LTB01110NAS1

TECHNICAL BULLETIN

501-19: Bumpers

Rear Bumper Exhaust System Heatshield Modification

1

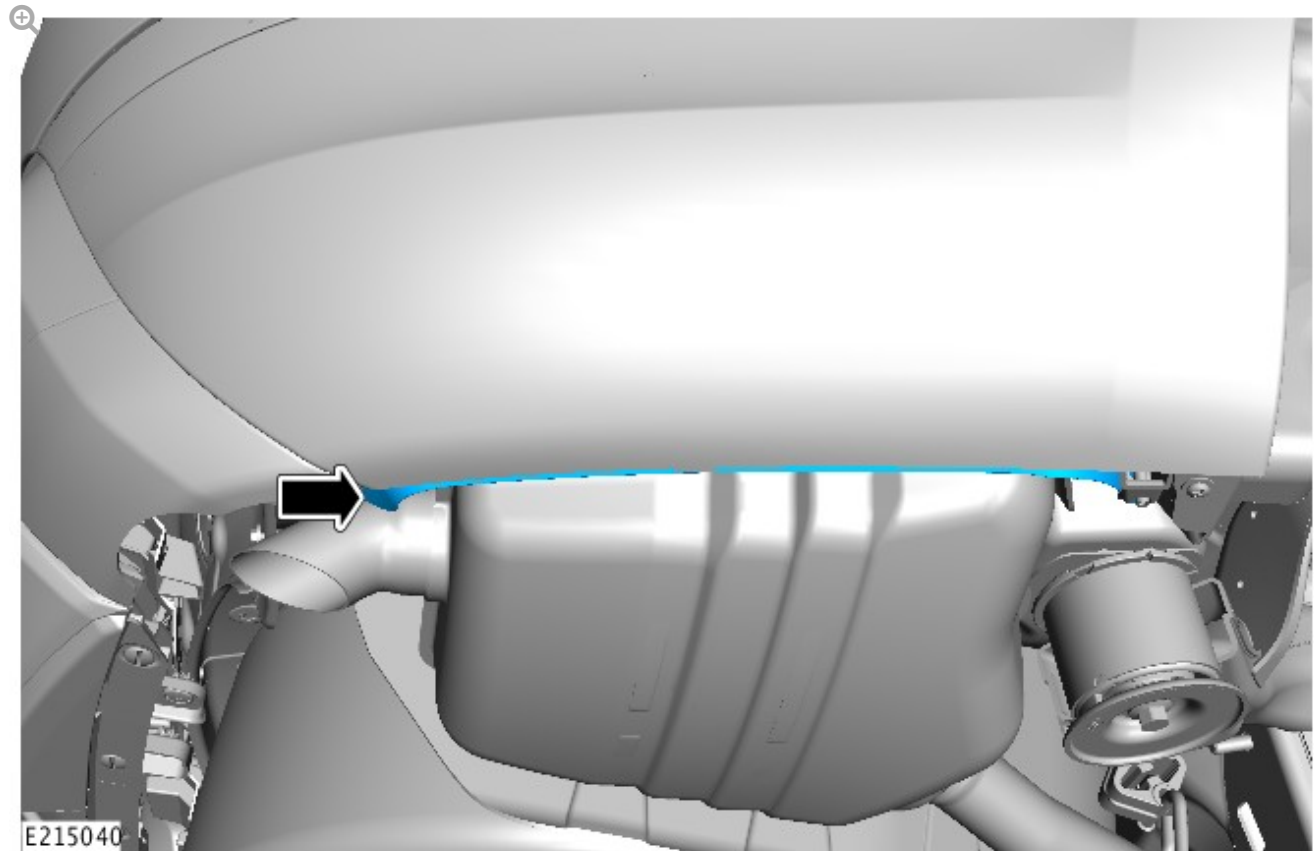
Approximate position of the exhaust system right heatshield. Exact position may vary between vehicles.

2

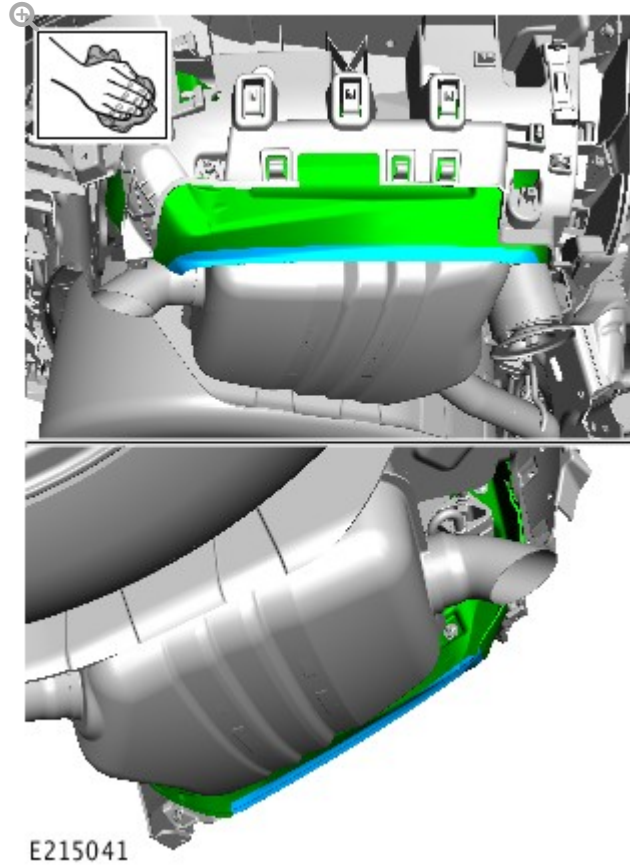
Using a suitable solvent cleaner, prepare the bottom edge of the exhaust heatshield for the self adhesive aluminum tape.

3

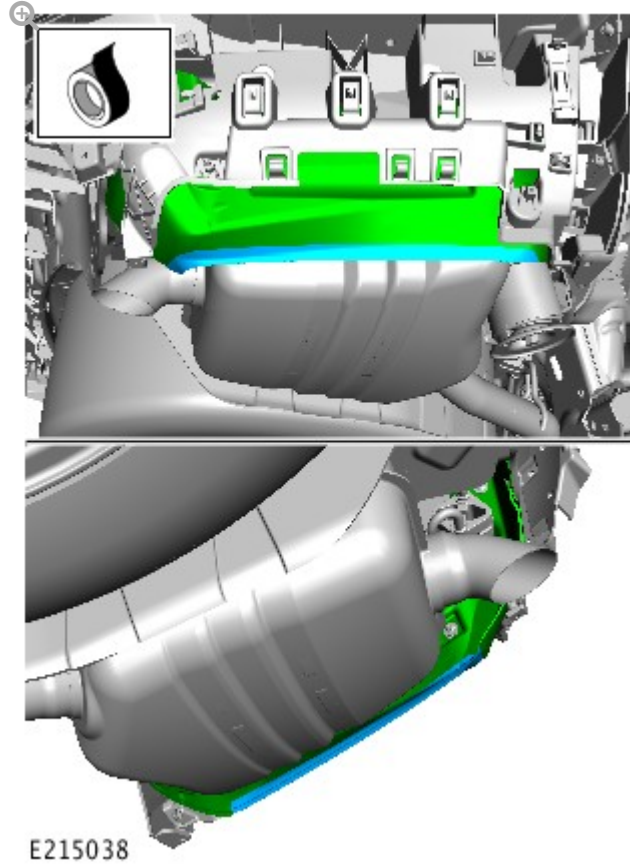
Install aluminum tape to the bottom edge of the heatshield.

- Fold the self adhesive aluminum over the edge of the heatshield.
- Press the tape firmly to make sure it adheres fully.

4

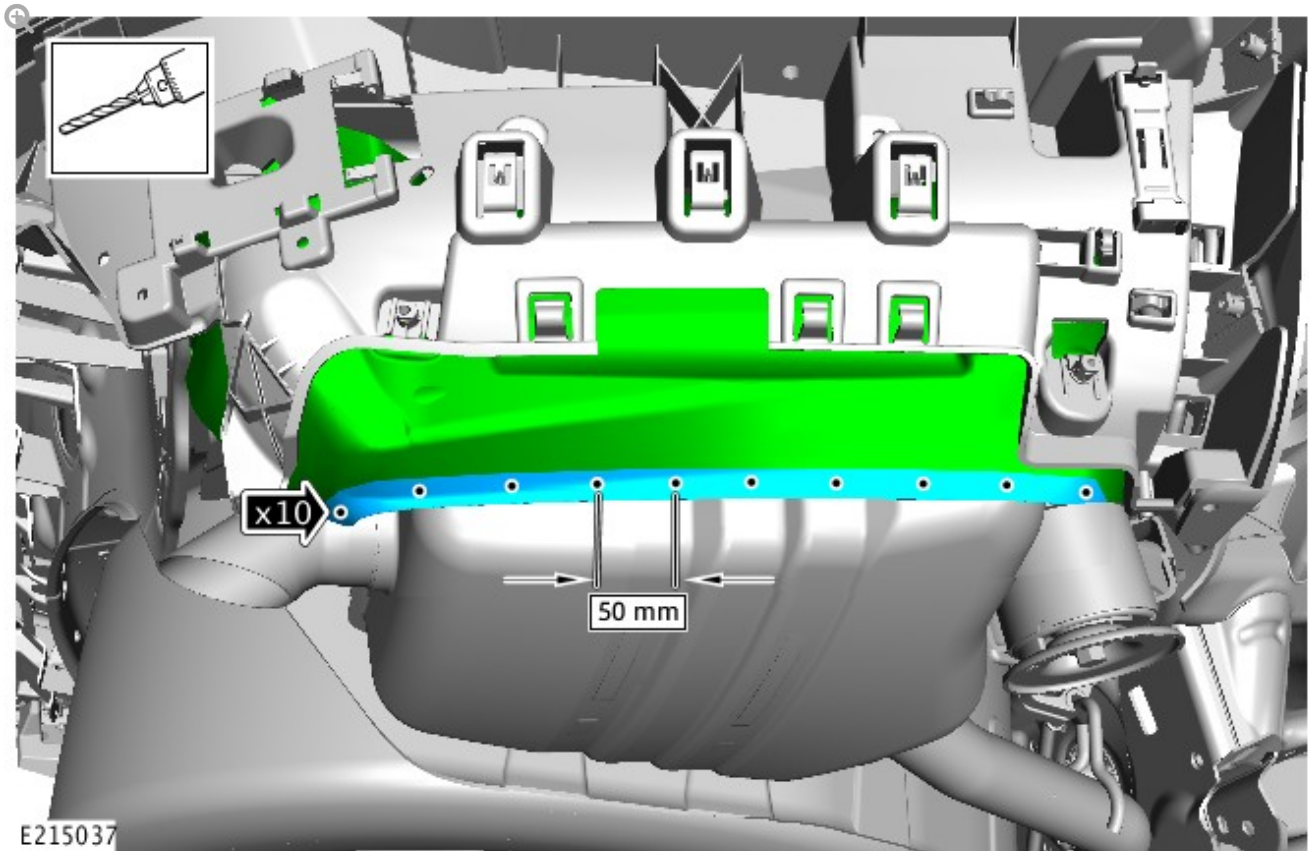
Use care to not damage muffler or other components.

Measure and mark 10 positions 50 mm apart along the edge of the tape.

- Using a 3.3 mm drill, make a hole at each mark.

5

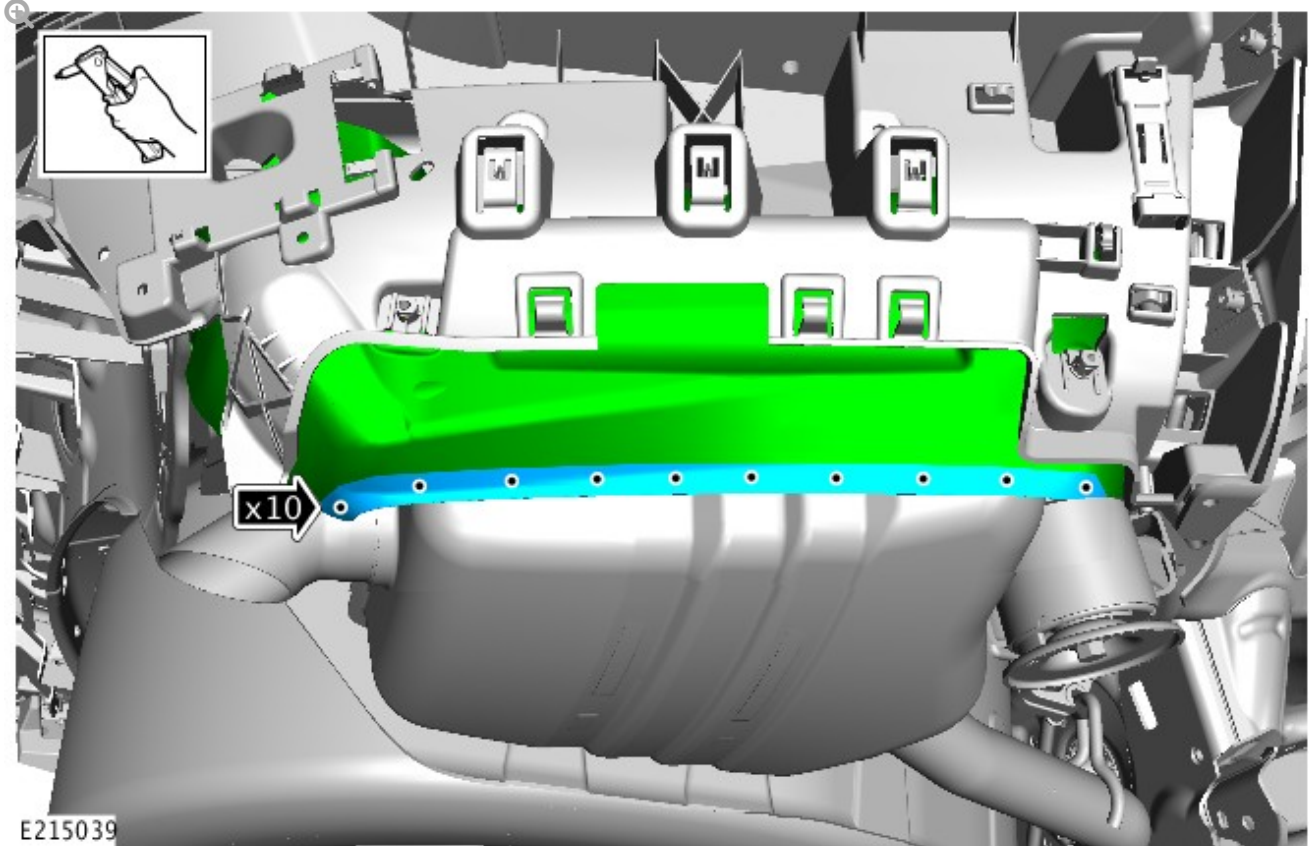
Install one (1) 3.2 mm breakstem fastener into each of the 10 holes made in step 3 to secure the tape.
